AMENDMENTS TO THE DRAWINGS

Patent Application Docket No. 08856-00015USPT

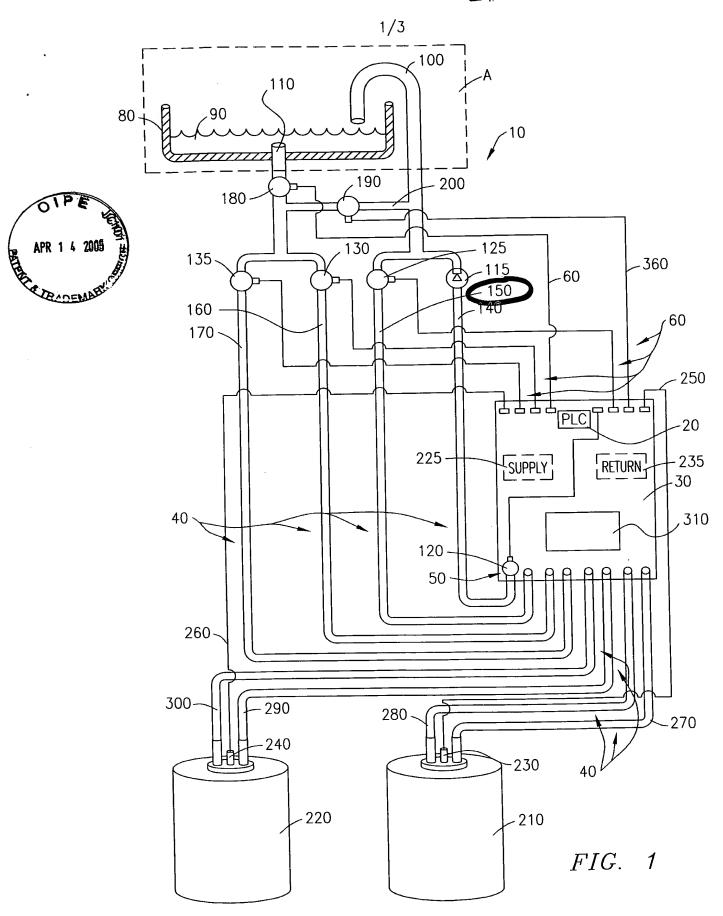
Figure 1 has been amended to correct an error changing element 500 to element 150 so that it coincides with the specification.

FIG. 4

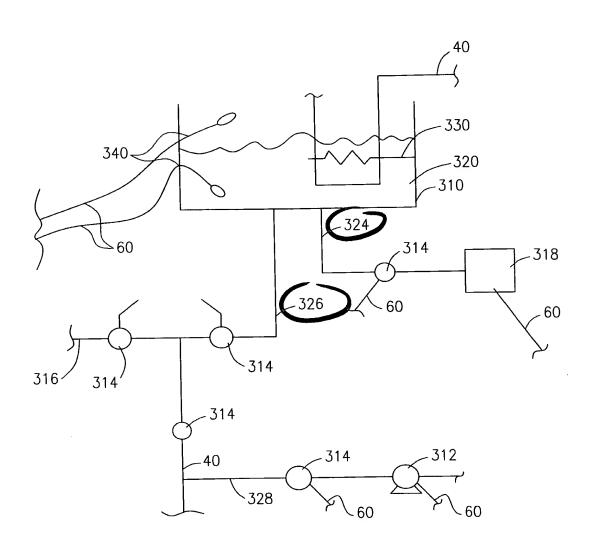
Figure 4 has been amended to include elements 324 and 326 so that they coincide with the specification at page 12, lines 11-20.
